LuK Nr: 128 0055 11 – 280mm DBVR

Bulletin 988 2000 960

CASE IH, MANITOU, VOLVO**

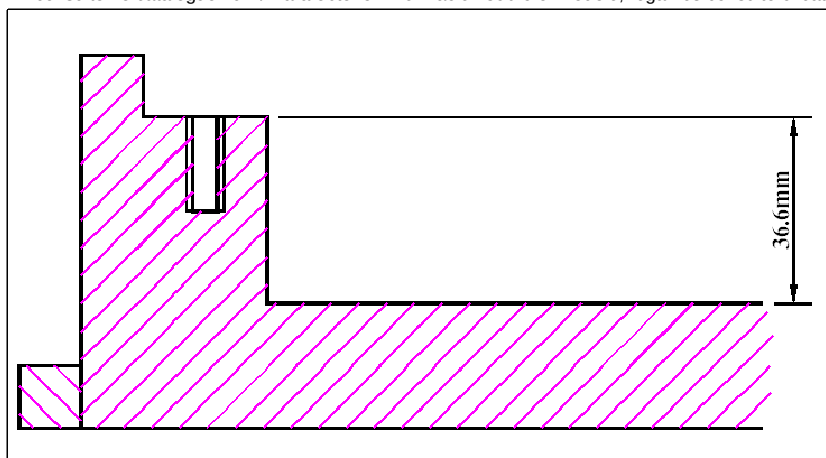
Info:	128 0055 11 replaces / ersetzt / remplace / sustituye a / sostituisce 128 0055 40 + 128 0055 41
(GB)	Please ensure that the flywheel is machined to a pot depth of 36.6mm.

(D)	Das Schwungrad ist auf eine Tiefe von 36.6mm auszdrehen,siehe unten.
(F)	Veuillez vous assurer que le volant-moteur est rectifié à une profondeur de 36.6mm.

(E)	Asegúrese de que el volante está mecanizado hasta una profundidad de 36.6mm.
(I)	Controllare che il volano venga rettificato a una profondità di 36.6mm.
LuK Repsets:	628 1032 07 = 128 0055 11 + 328 0175 42 + 500 1046 50 + 410 0026 00 628 1032 09 = 128 0055 11 + 328 0175 42 628 1033 07 = 128 0055 11 + 328 0175 41 + 500 1046 50 + 410 0026 00 628 1033 09 = 128 0055 11 + 328 0175 41 628 2590 07 = 128 0055 11 + 328 0175 40 + 500 1046 50 + 410 0026 00 628 2590 09 = 128 0055 11 + 328 0175 40 628 2592 07 = 128 0055 11 + 328 0175 10 + 500 1046 50 + 410 0026 00 628 2592 09 = 128 0055 11 + 328 0175 10
	128 0055 11 – 128 0055 12 + 434 0342 10
